CENTRAL LAND COUNCIL

Submission to the Northern Territory Environmental Protection Agency (NTEPA) for Verdant Minerals' Ammaroo Phosphate Project - draft Environmental Impact Statement.

December 2017

Appendix 1: CLC Map 2017-412

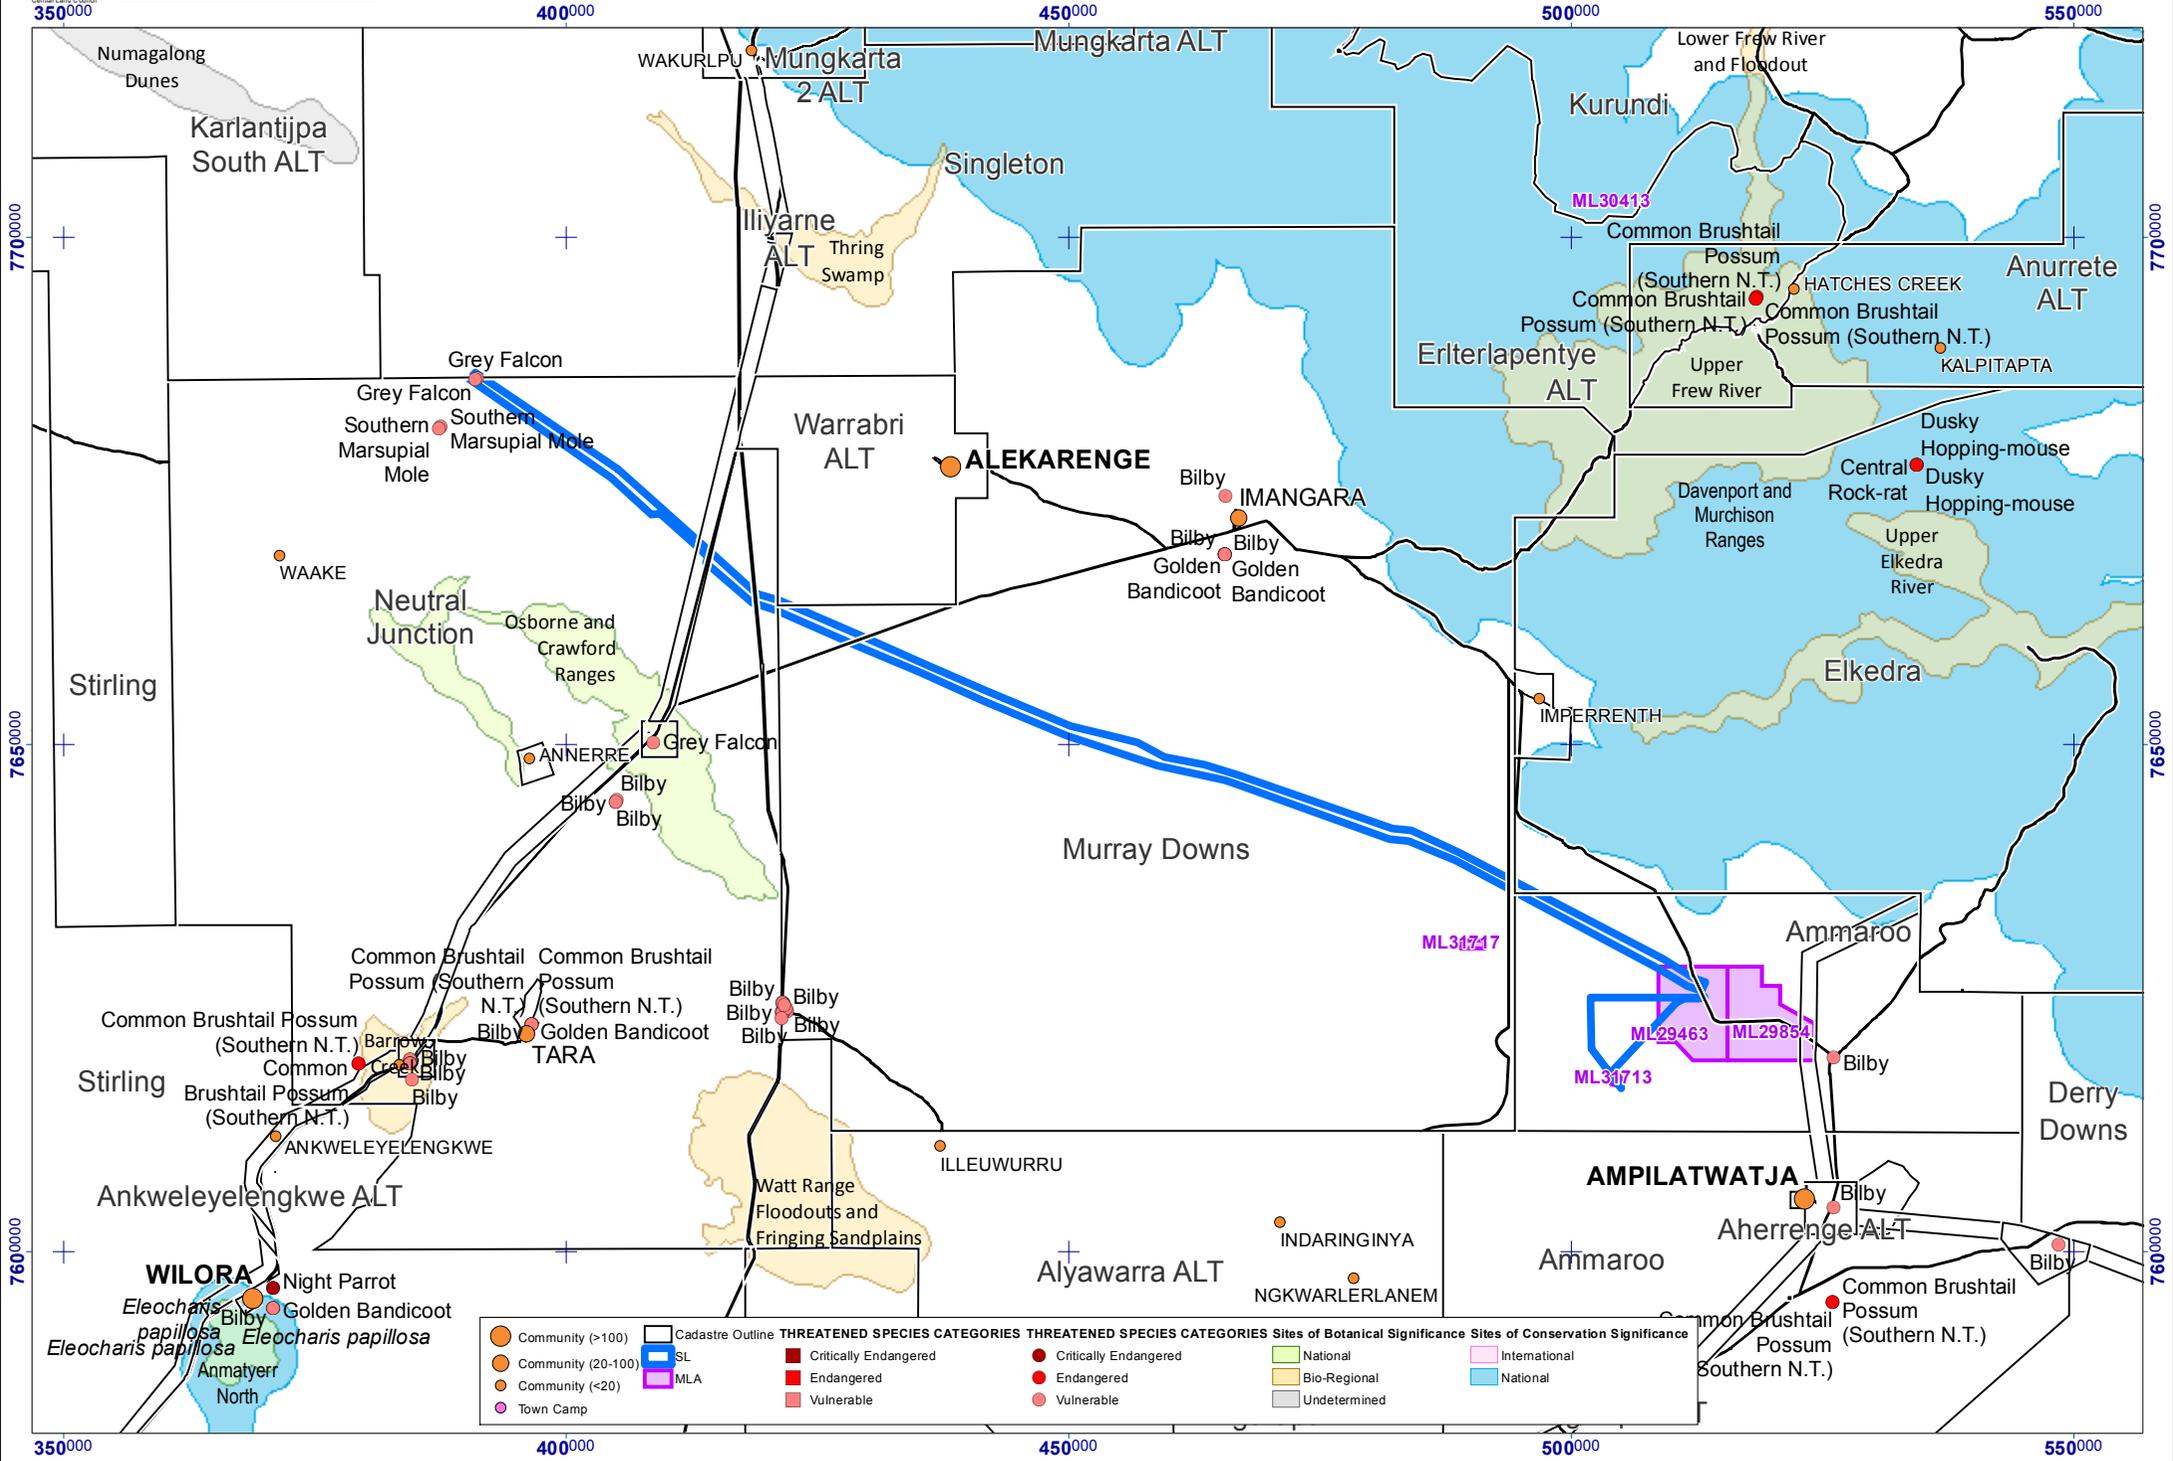
- The CLC is concerned about the impact on fauna by the Infrastructure Corridor and the Mineral Lease areas. The Native Title Holders believe there are Bilbies in the Project area and the CLC can share data that supports this view. Map 2017-412, attached in Appendix 1 shows, the Infrastructure Corridor and MLAs bisect part of the known range of the Greater Bilby based on CLC and NT Species Atlas records (e.g. known population from records up to 2010 on the railway line near Illeuwurru and other records from further north and east). In addition there are records close to the eastern boundary of the MLAs closer to Ampilatwatja.

- Greater consideration to the potential impacts on Bilbies be undertaken (e.g.,

restricting range of movement, potentially increased predation) including a more extensive and targeted tracking survey to be carried out by an experienced Bilby survey team with the view to developing an appropriate management response as needed. This should also include other significant species (e.g., Marsupial Mole, Golden Bandicoot) that are proximal to the proposed transport corridor and the Project area.
